APPARELWERKS

Pattern DXF file inspection and ASTM D6673 compliance evaluation

jacket2_40-146_marker_allsizes_R13_202610121149.dxf

Analyzed 12 October 2026

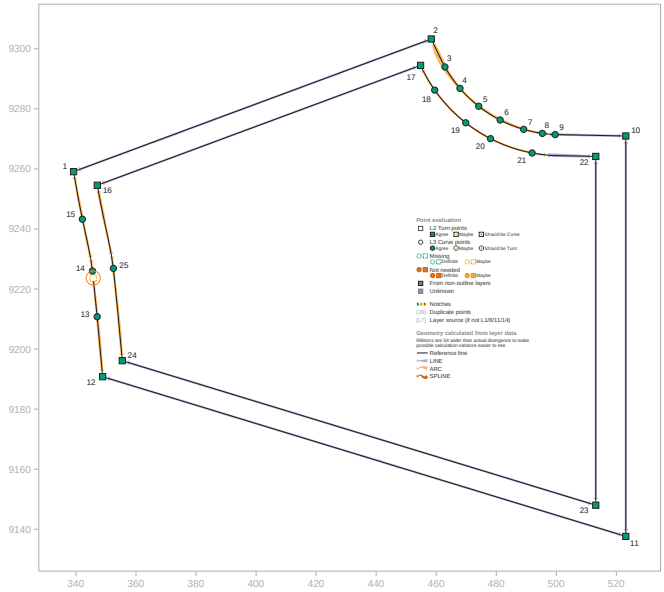
departure

Excluded layers present in graded sizes

Graded size 220 carries layer 2, a sample-only layer that must not repeat in graded sizes.

ASTM D6673 §4.3.1.5
